UNITED STATES
NUCLEAR REGULATORY COMMISSION
WASHINGTON, D. C. 20555

Docket No. 50-213
LS05-80-11-046

PLANT DESIGN CHANGE REQUEST

TITLE	Spent Resin Storage Facility	PA 79-259
-------	------------------------------	-----------

LOU YANKEE ATOMIC POWER COMPANY
SPENT RESIN STORAGE CELLS
FIG 2

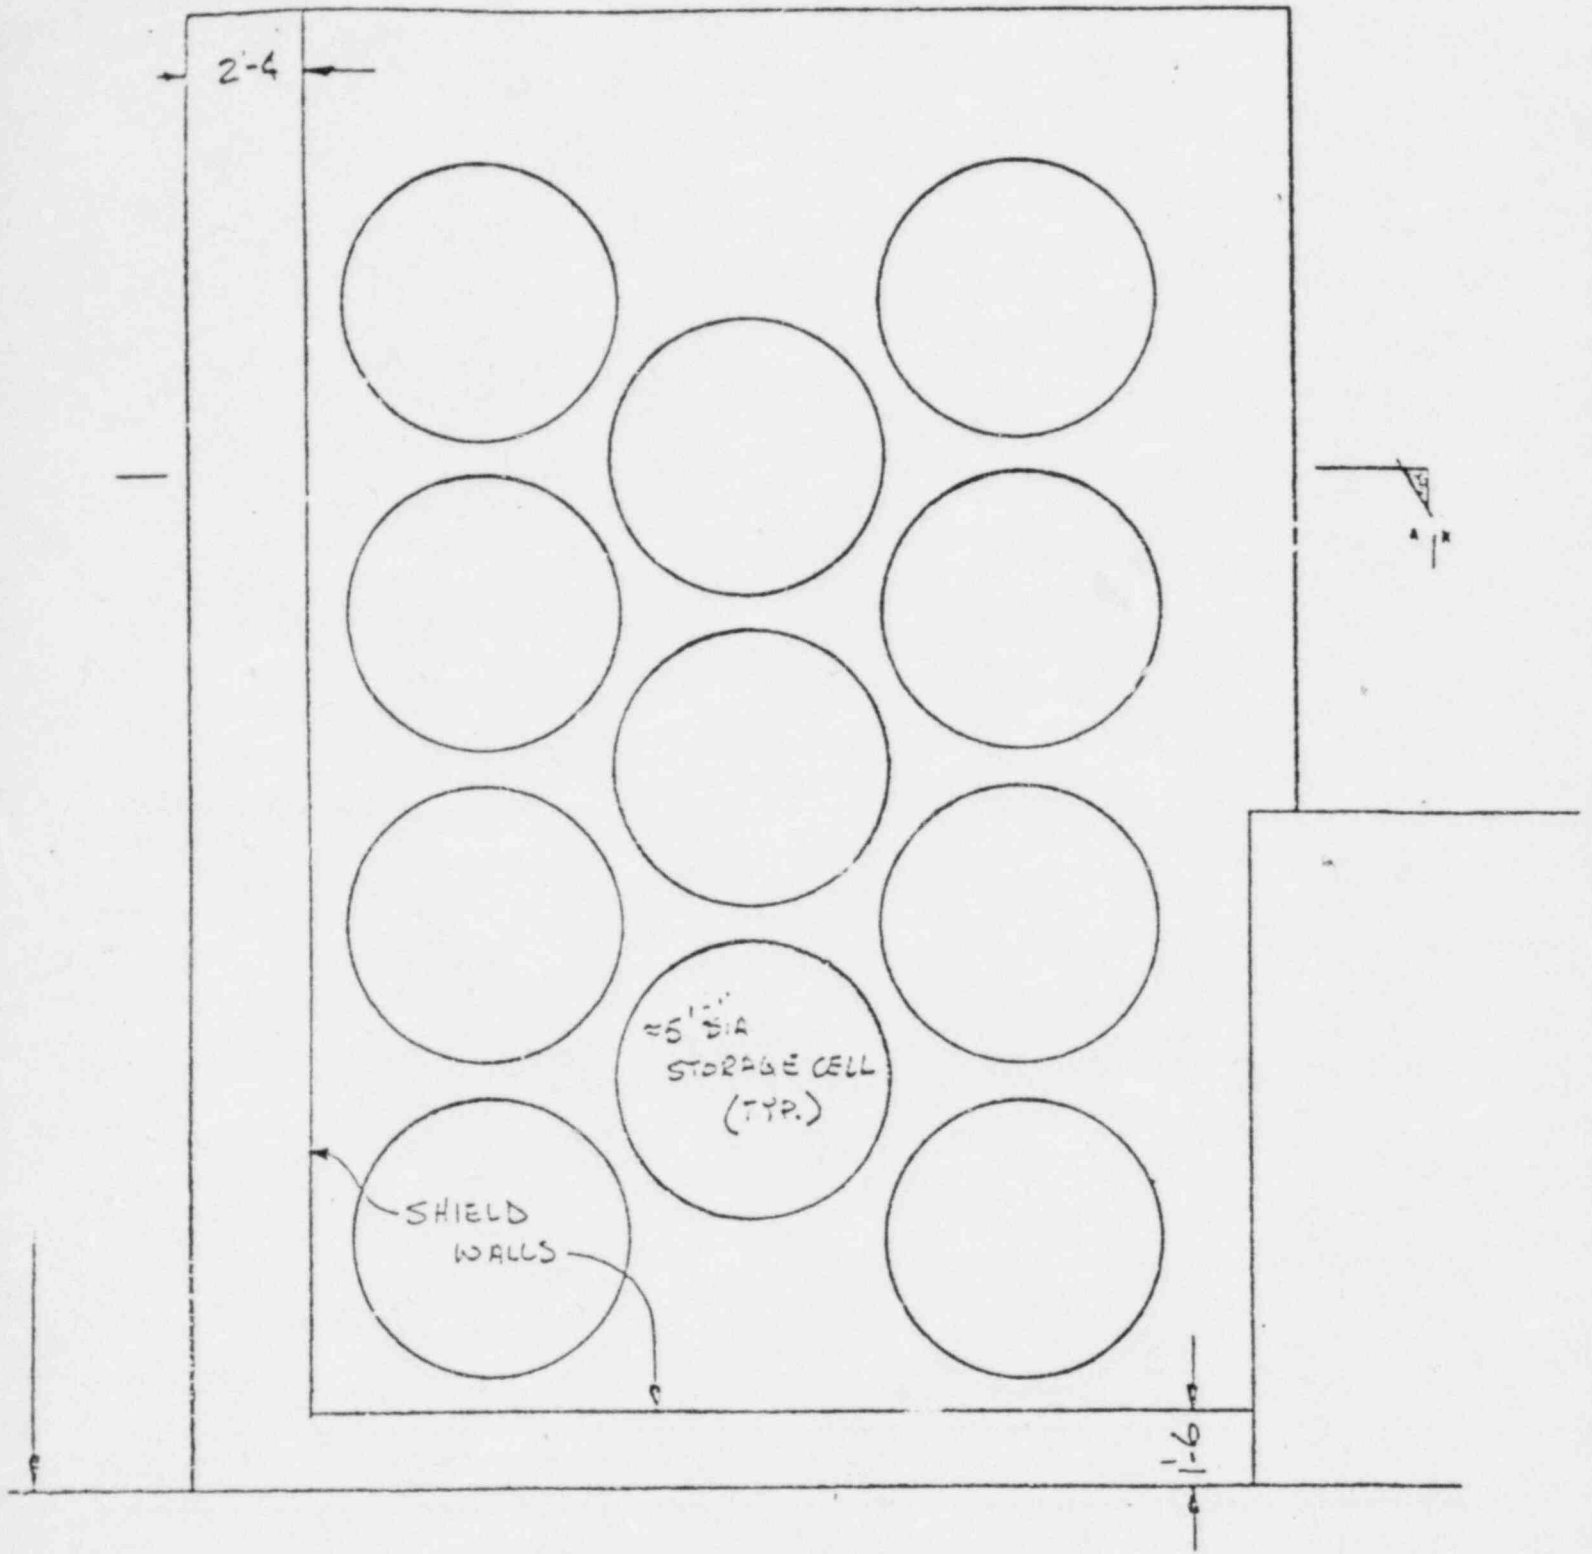
In order to facilitate the transferring job, a bevel should be built on top of each cylindrical cell.

The sketched drawings show the ID of the cylindrical cells as 5'. Since Chem. Nuclear resin liners are 5'1" diameter (OD), the cells ID should be changed to 5'2".
